Engineering Evaluation of Bollard Fence

Rio Grande, Hidalgo County, Texas

United States of America v. Fisher Sand and Gravel Company, Civil Action No. 7:19-CV-403

August 2021

Figure 4.4. TGR HEC-RAS model-simulated whirls and eddies

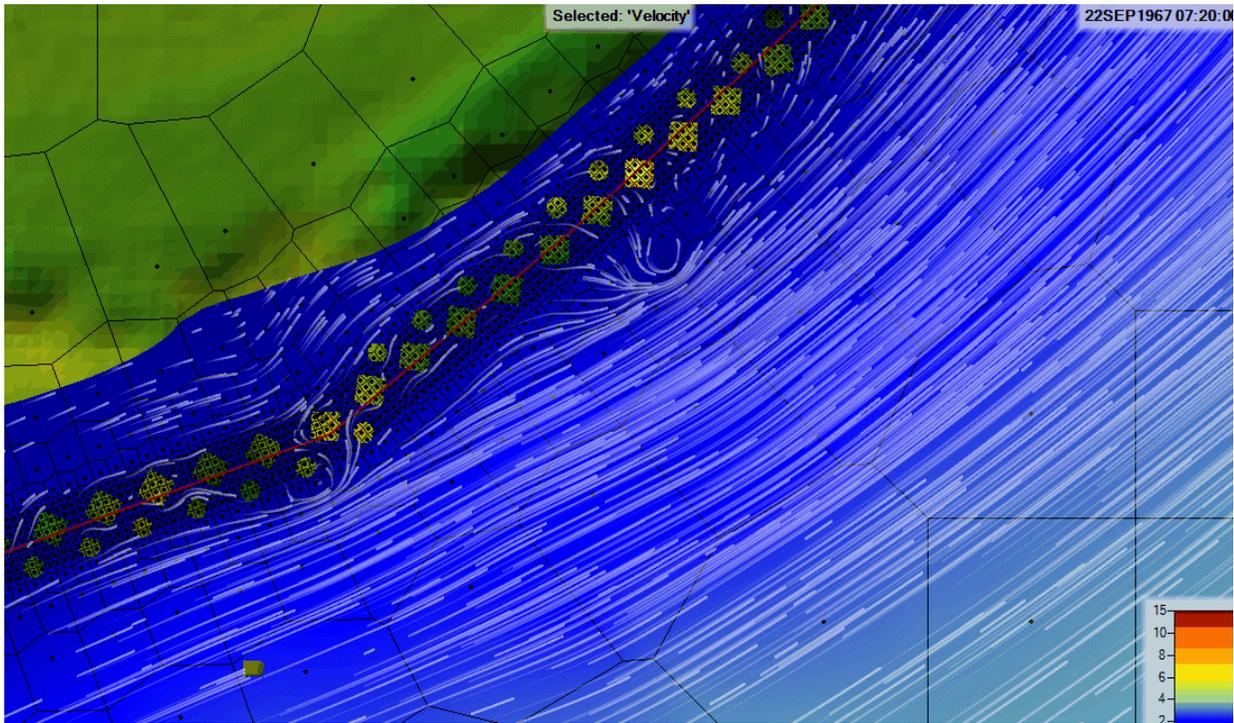
By distorting the horizontal dimensions of the bollard fence by a factor of 12, the 2D TGR model does not preserve hydraulic similitude. For any given river flow depth and velocity, flow and turbulence around 6-foot bollards spaced 5 feet apart are not similar to flow around 6-inch bollards with 5-inch openings. As shown in Figure 4.4, the TGR model simulates large (10 to 20 feet) whirls and eddies along the riverbank and fence, which ordinarily would not be expected to occur with river flow velocities between 2 and 4 fps. In addition, velocities of 8 to 10 fps are shown in Figure 4.5 at the downstream terminus of the fence where velocities would be expected to fall as the reservoir fills. Large-scale turbulence and high velocities simulated by the TGR model do not appear to accurately characterize river and floodplain hydrodynamics with flow velocities averaging less than 4 fps as simulated by the subsequently described Arcadis HEC-RAS model. The TGR report does not disclose high velocities and turbulence simulated by its model and does not propose or discuss mitigation measures.

Figure 4.28. Maximum water surface elevation along Mission Levee (light blue – post-project, blue – pre-project, green – base elevation)

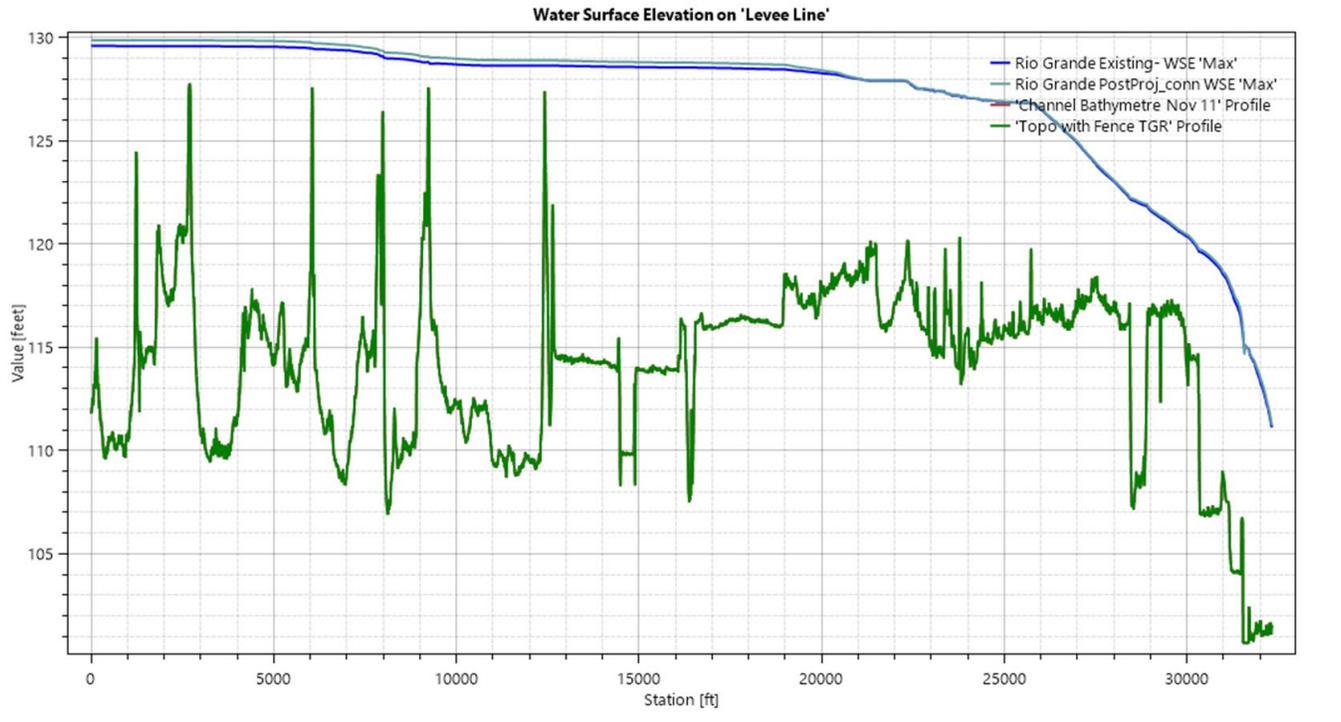
The data show that freeboard is reduced by up to 0.29 feet on the western and middle portions of the levee (Station 0 – 20000 in Figure 4.28) and by up to 0.06 feet on the eastern portion of the levee (Station 20000 – 32000) due to the fence.

Figure 4.31. Maximum velocity plumes through typical unblocked openings on eastern portion of fence

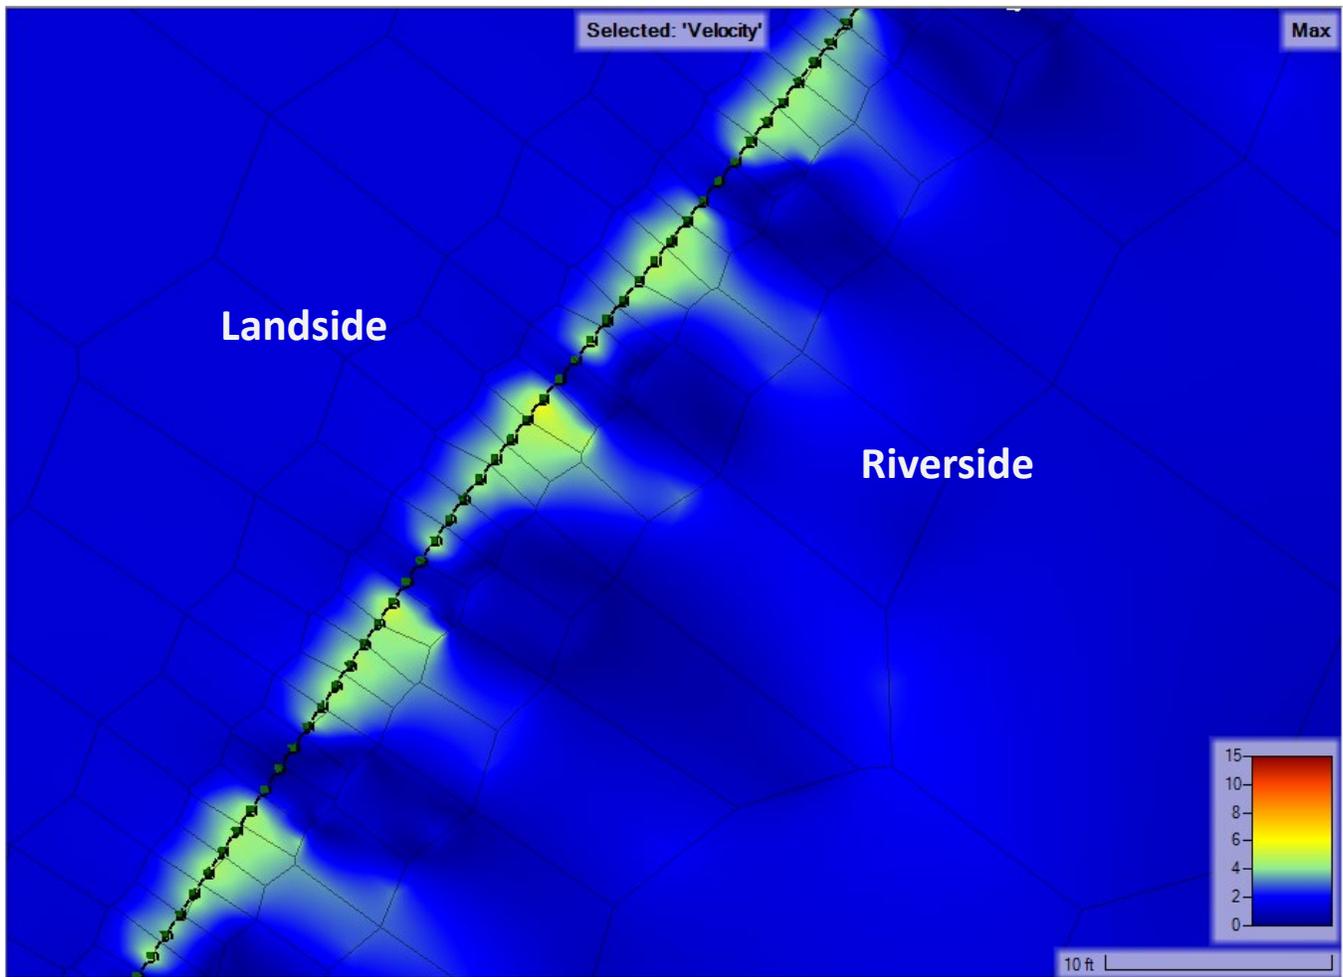
Figure 4.31 shows a color-coded map of maximum velocities through typical unblocked openings on the eastern portion of the fence. Figure 4.32 zooms out, showing the prevalence of high-velocity openings along the eastern fence line. Both figures show high-velocity plumes extending for several feet to the outside (river side) of the fence.

- Severe erosion of the base of the fence has occurred in some locations with rills and gullies as shown in Figure 4.34, indicative of high flow velocities through the fence openings from inside to the outside. As displayed in Figures 4.31 and 4.32, such conditions primarily occur along the eastern portion of the fence on the rising side of the flood hydrograph in this case. Without protective measures, for example armoring of the slope by riprap or soil reinforcement by natural vegetation, erosion of this type could expose and weaken the foundation of the fence over time.

Figure 6.2. TGR typical wall elevation

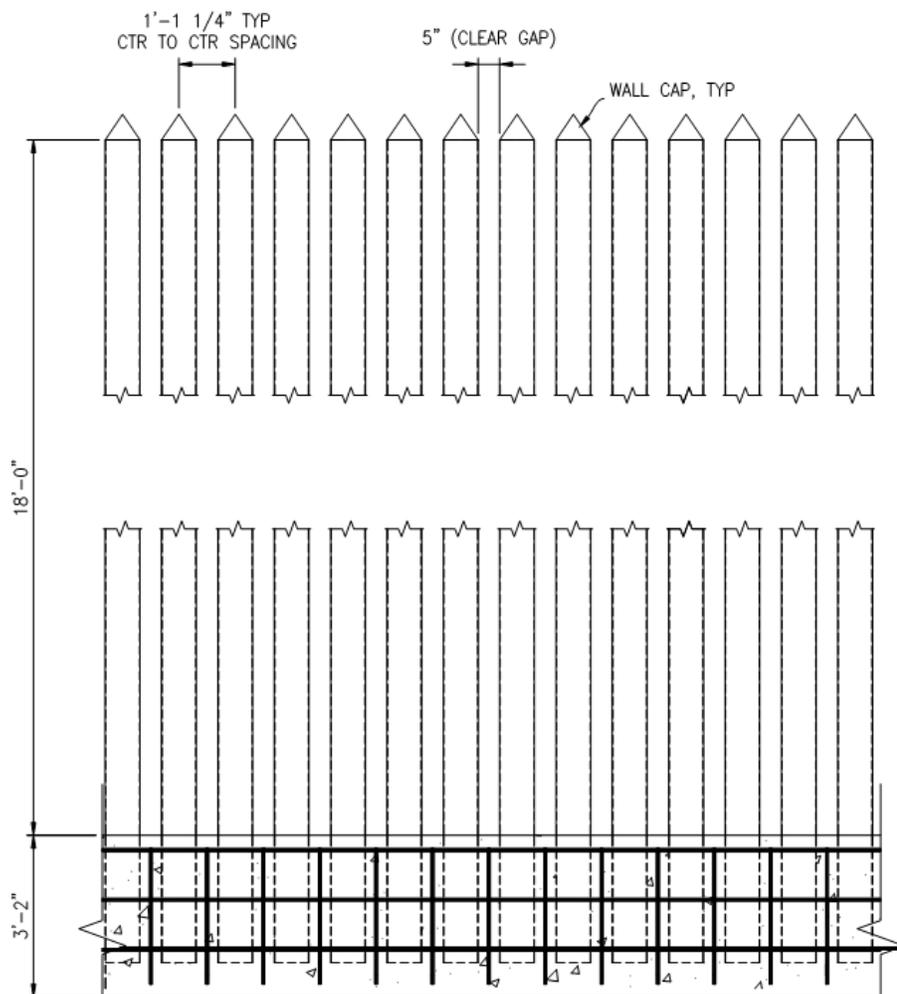
The typical system cross section depicts the 3-foot-diameter 6-foot-long precast shaft protruding 2 feet above grade, as shown in Figure 6.1. The fence bollards are 1 foot and 1¼ inch on centers and have a clear space of 5 inches along the centerline of the fence, as shown in Figure 6.2.

Figure 1: Construction Details from Plans by TGR Dated October 30, 2019

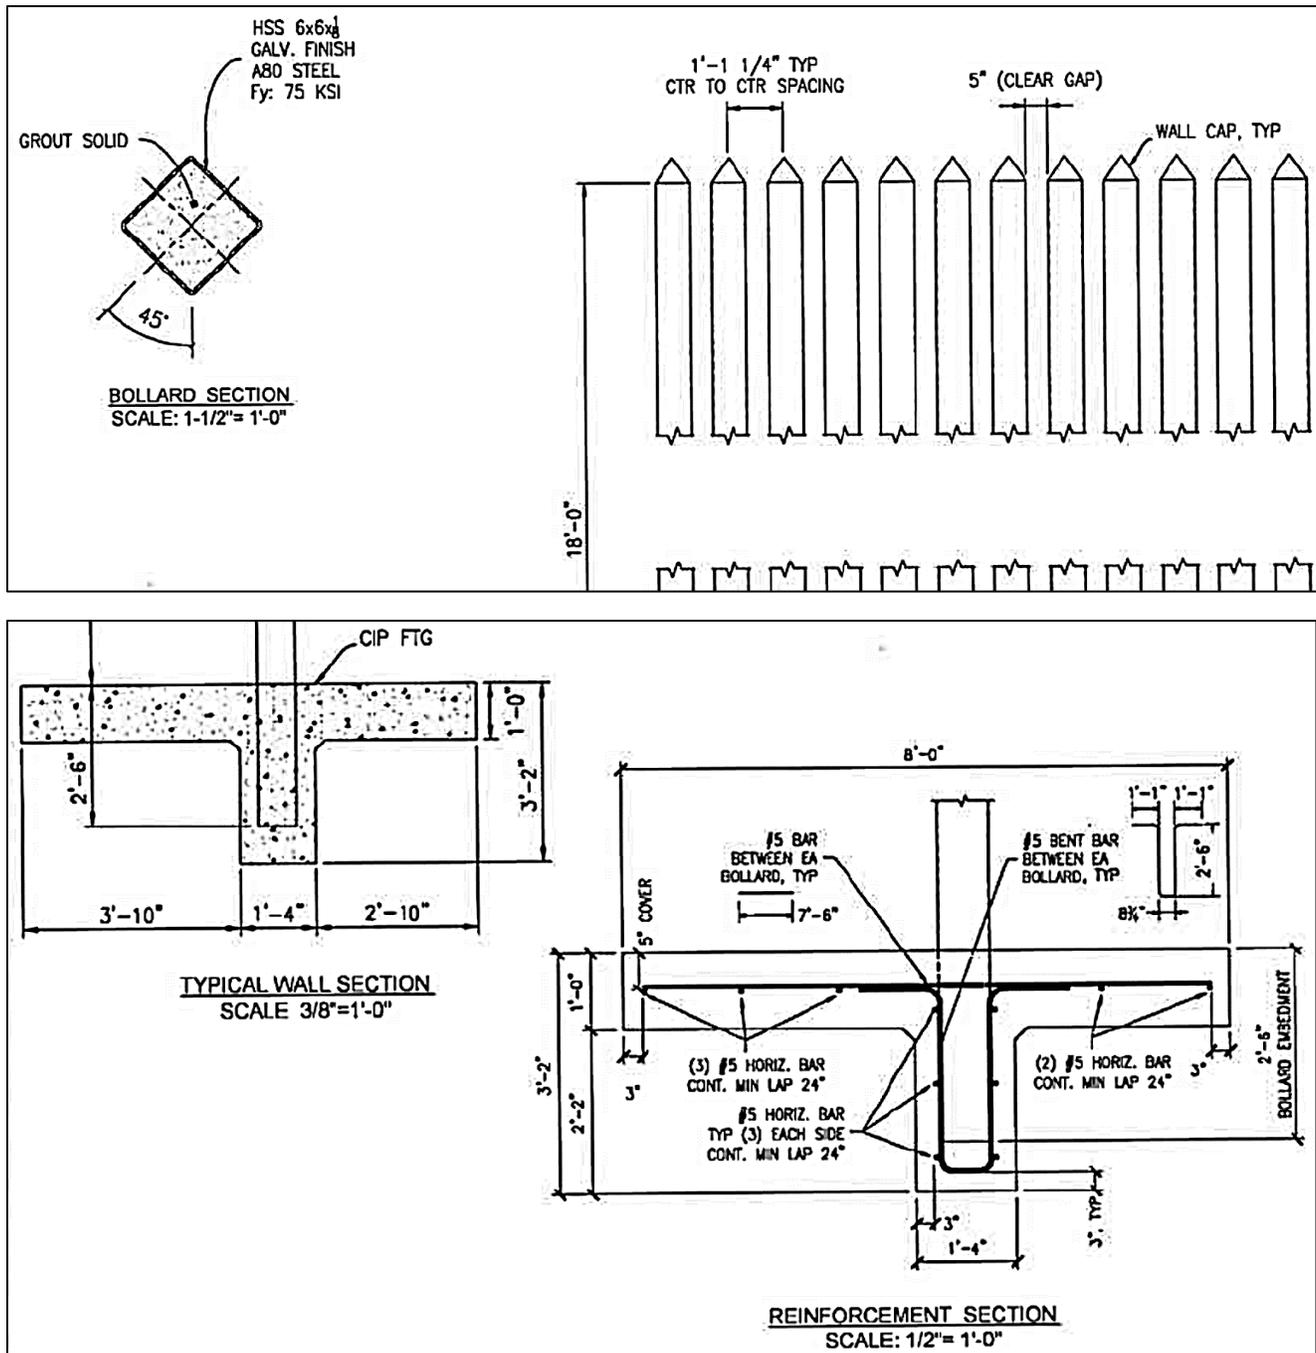
Mr. Fisher reported that the fence was constructed as shown on the plans provided (details shown on Figure 1). An exception is that the bollards were not grouted solid as shown on the plans, and instead were backfilled with an unspecified grade “pea” gravel. No material specifications, quality control test results, or field reports were provided regarding the backfill of the bollards and no field verification was completed for this investigation. Pre-cast concrete caps were grouted to the top of the fence bollards using a rebar dowel. Shop tags providing records of galvanizing and photographs of example materials are shown on Figure 3.

The depth of the concrete footing shown in the design (Figure 1) is 1 foot up to the steel bollards, where the depth increases to 3 feet for the embedment of the bollards. The edge of the footing on the riverside of the fence was evaluated at five locations along the alignment to confirm the depth of the concrete. This evaluation indicated that the edge of the concrete is not a uniform depth of 1 foot, with one location measuring as little as 4.5 inches as shown on Figure 14. One location evaluated near STA 156+00 did measure a full 12 inches as shown on Figure 15.
